**Project:** TAUMATATOTARA WIND FARM - APPLICATION RM200019      **Memo:** 6/R1      **Page:** 1 of 15

**Topic:** Assessment of Landscape & Visual Effects– Review

**Date:** 13 September 2023

**From:** Dave Mansergh – Consultant Landscape Architect for Waitomo District Council

Figure 3: Attachment 1 from the LVA

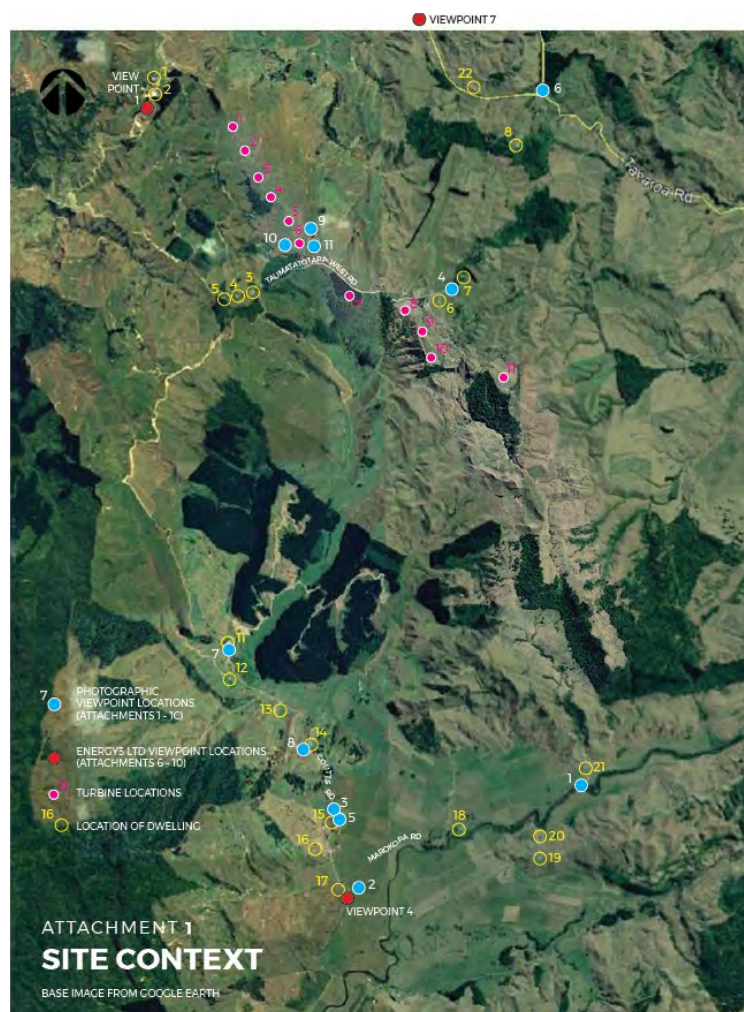
The assessment of visual effects section of the LVA evaluates the visual effects of the proposed modification against those of the previously consented wind farm. The LVA identifies that the effects on visual amenity from the dwellings identified in Figure 3 (above) were considered and rated. ZTV mapping was used, supplemented by field-based observations and line-of-sight analysis, although some details like vegetation that could obscure views were not included.

- a. Dwelling '22': Newer and not part of the original consent. Views were assessed from a nearby road. 10 of 11 new turbines are expected to be partially visible, compared to 4-6 in the original scheme.
- b. Dwellings '18' and '21': Fewer but taller turbines will be visible, reducing overall visual impact.
- c. Dwellings '19' and '20': 1-3 new turbines visible due to local topography, fewer than in the original scheme.
- d. Dwellings '14' to '17': Reduced but still significant visibility. Effects considered 'low-moderate' positive.
- e. Dwelling '13': Likely full screening by local topography and possible forestry, much reduced from the original scheme.

It is unknown if these dwellings were assessed or reviewed by the author of the WSP report. This should be clarified at the hearing.
